DOCUMENT 00 0491  
ADDENDUM NO. 2

DATE: February 10, 2010  
PROJECT NAME: Greene County Medical Center AHU Replacement

**MSK-4**

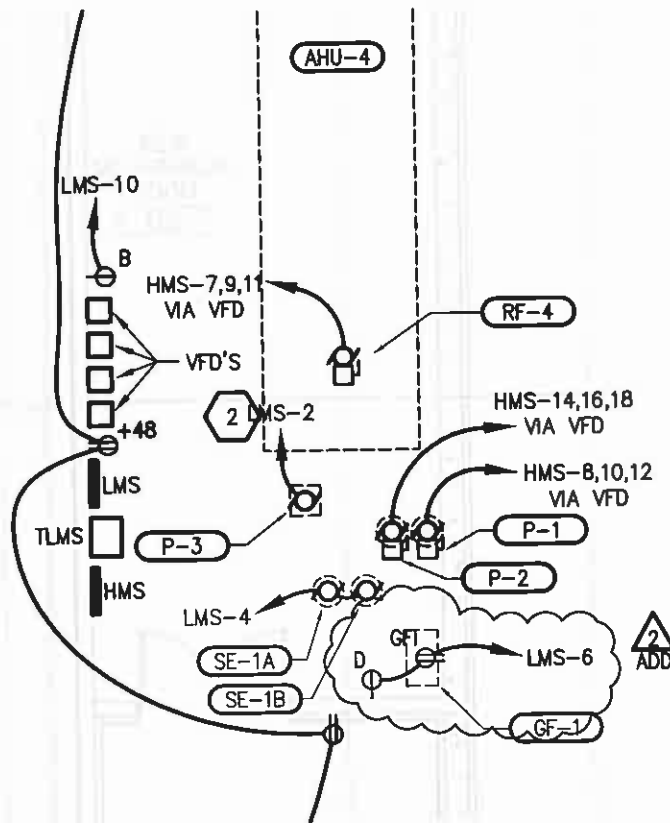
6. Sheet M3.02 – MECHANICAL DETAILS
  - a. **REVISE** Detail 7 to accommodate glycol feed to 2 separate systems as shown on sketch MSK-4 as attached to this addendum.
